**Freightliner
Service Bulletin**

Description of Revisions: *This bulletin replaces the previous version dated December, 1997. The part number for the new sensor has been revised.*

The optimized idle feature on vehicles equipped with a DDEC III engine and ESS (Electronic Syncro Shift) has been "dropping out," or not working at all. This can occur because the vehicle speed sensor may be too sensitive.

Fig. 1, Magnetic Sensor Installation (cutaway view)

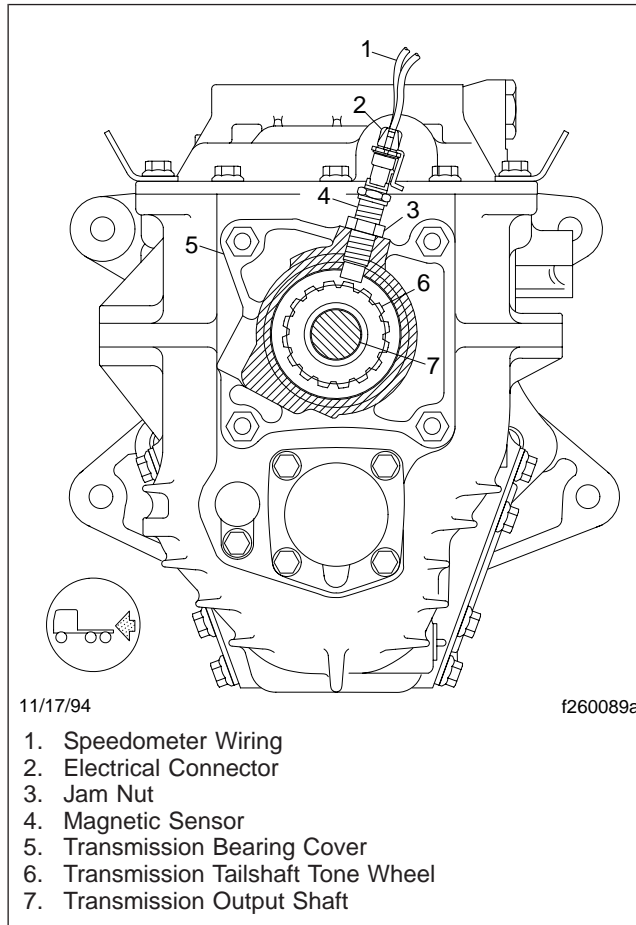
Production plants will begin installing a new sensor that will have a Metri-Pak connector instead of a Weather-Pak connector.

5. Screw the new sensor (p/n 681 542 13 17) into the transmission cover until it bottoms out in the transmission. If no plastic shim is installed on the sensor, back the sensor out one-half turn. See [Fig. 1](#).

NOTE: If the plastic shim is installed, do not back out the sensor. The gap has already been set by the plastic shim.

6. Hold the sensor in place to keep it from turning. Tighten the jam nut 18 lbf-ft (24 N·m).
7. Connect the jumper harness (p/n A06-19868-020) to the sensor and the wiring harness.
8. Remove the chocks from the tires.
